ADDENDUM NO. # 12

INVITATION TO TENDER No.: FIN2026-152T

TITLE: Barrie City Hall – Fourth Floor Renovation

ADDENDUM ISSUE DATE: Tuesday, November 17, 2026

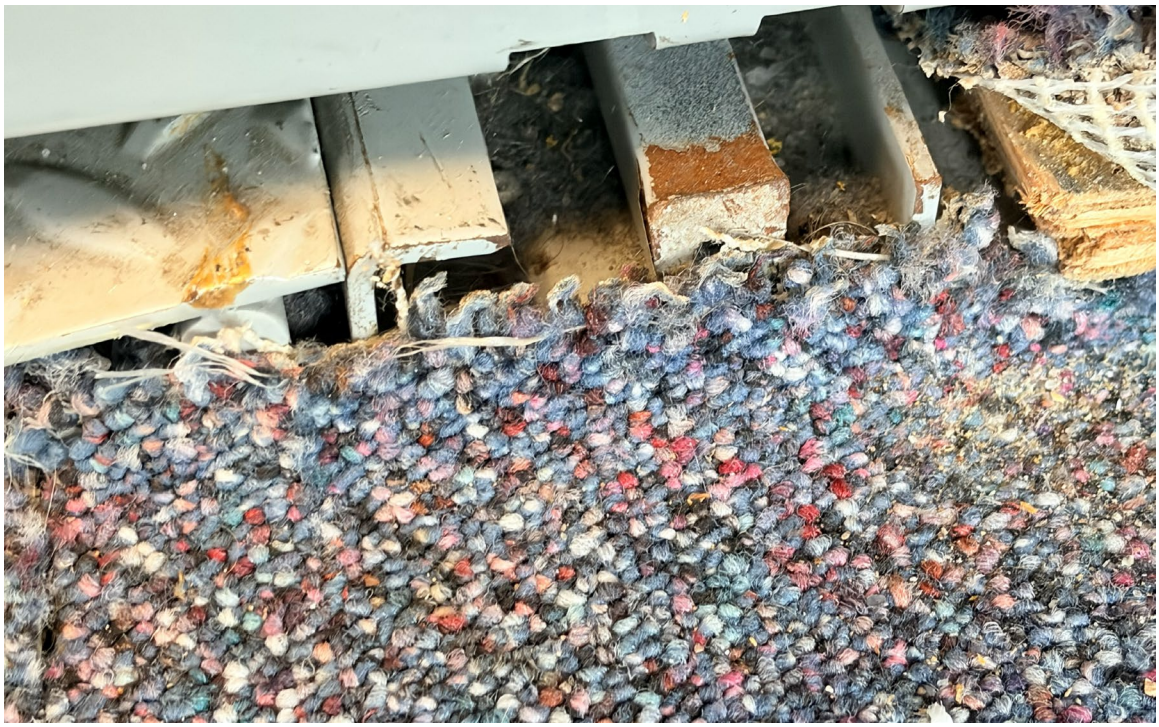
The intent is to retain and reuse the existing HDF system in its current location, with the overall system width reduced through the removal of two (2) carriages and reconfiguration of the remaining system.

The existing raised platform consists of recessed metal tracks within a raised floor assembly. Existing conditions indicate plywood infill between track sections. The photographs below are provided for reference and illustrate the existing HDF system, shelving configuration and associated track system.

The modification shall include the removal and disposal of two (2) double-sided mobile carriages. The exact carriages to be removed shall be reviewed and confirmed with the City's Project Manager prior to commencement of the Work.

The existing raised platform consists of recessed metal tracks within a raised floor assembly. Existing conditions indicate plywood infill between track sections.

Existing shelving, dividers, and filing accessories shall be reused and reconfigured within the modified HDF system as required to accommodate the City's filing folders and paper records storage boxes. Approximately six (6) to seven (7) shelf openings per retained carriage are anticipated.
      Refer to Attachment 1 – Drawings and Specifications, Sheet A100.
